## SUNDRY NOTICES AND REPORTS ON WELLS

## Lybrook No. 2

### Plugging & Abandonment Procedure

CONDITIONS OF APPROVAL

## Lybrook No. 2

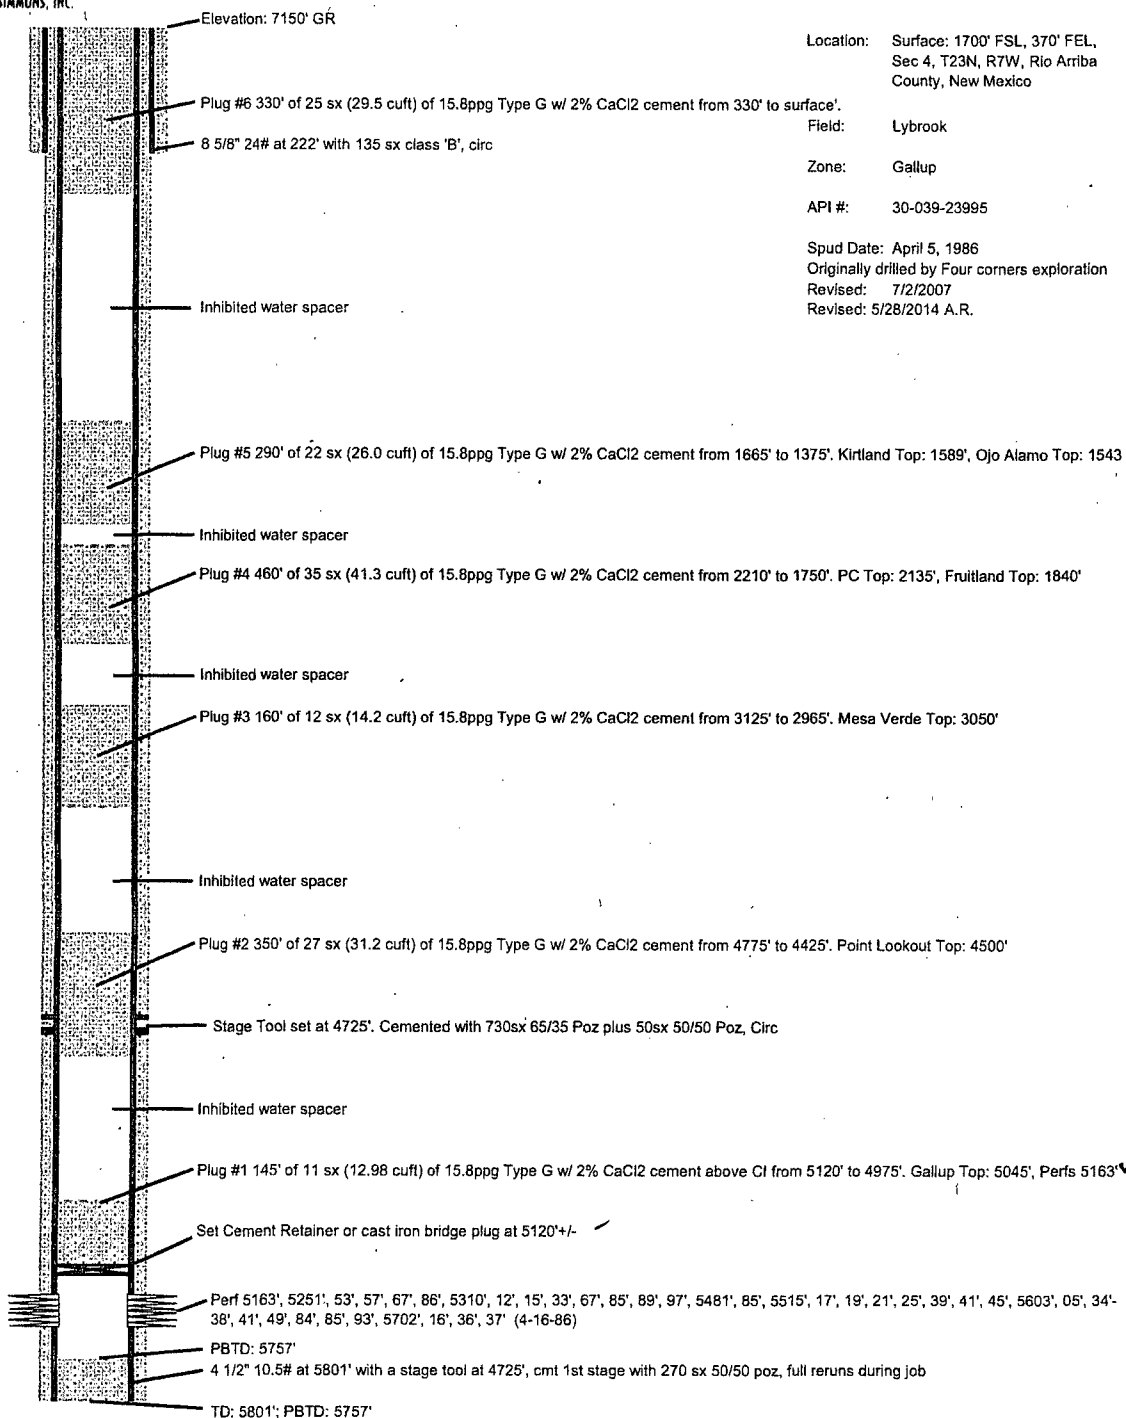
1. Plugging operations authorized are subject to the attached "General Requirements for Permanent Abandonment of Wells on Federal and Indian Lease."
2. Farmington Office is to be notified at least 24 hours before the plugging operations commence (505) 564-7750.
3. The following modification(s) to your plugging program are to be made:
  - a) Bring the top of plug #3 up to 2899 ft. to cover the Mesaverde top. Adjust cement volume accordingly.
